Addendum 23 : Regulation No. 24 to be annexed to the Agreement

Amendment 1

UNIFORM PROVISIONS CONCERNING THE APPROVAL OF VEHICLES EQUIPPED WITH DIESEL ENGINES WITH REGARD TO THE EMISSION OF POLLUTANTS BY THE ENGINE

Model A

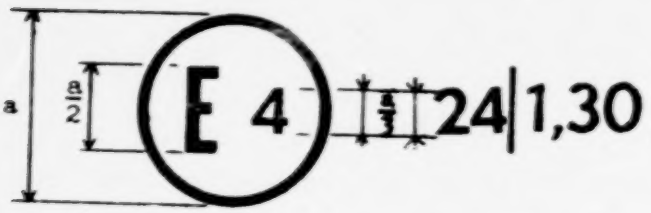
Replace Annex 3 by the following:

(See paragraphs 4.4. of this Regulation)

a = 8 mm min.

The above approval mark affixed to a vehicle shows that the vehicle type concerned has, with regard to the emission of pollutants by the engine, been approved in the Netherlands (E 4) pursuant to Regulation No. 24.
